RICHMOND AMERICAN HOMES JOB#28520014 LOT 24

DISAPPROVED
Plan Review

SFD20538
PLAT 14485
RS-5000 CAD-O

ADDRESS: 7012 PASSING SKY DRIVE

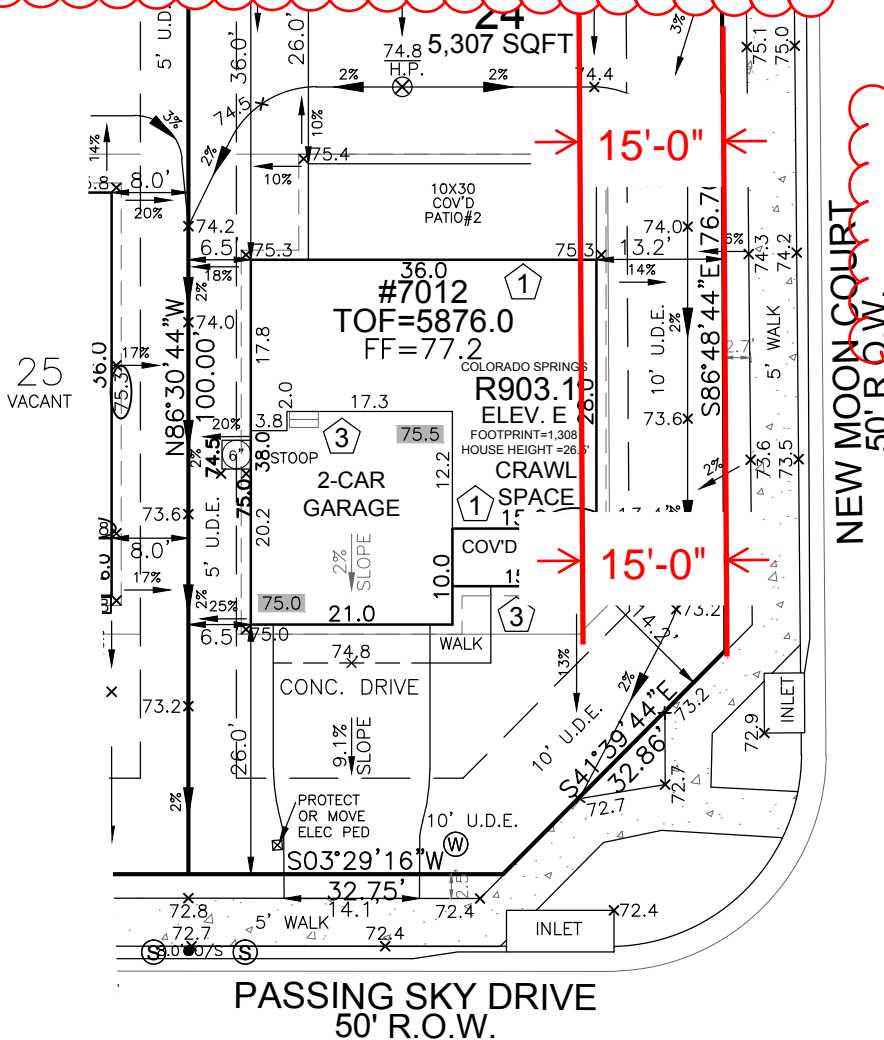
AN APPLICATION HAS BEEN MADE FOR ADMINISTRATIVE RELIEF TO ADJUST THE STREET SIDE YARD SETBACK TO 10' FROM THE REQUIRED 15' (SEE ADR205)

THE PROCESS IS AT THE INITIAL STAGE SO IT IS PREMATURE TO SUBMIT ANY SITE PLAN UNTIL APPROVAL FOR ADMINISTRATIVE RELIEF IS MADE. UNTIL THEN THE 15' SETBACK APPLIES AND ANY ENCROACHMENT WILL RESULT IN IMMEDIATE DISAPPROVAL.

house encroaching into street side yard setback
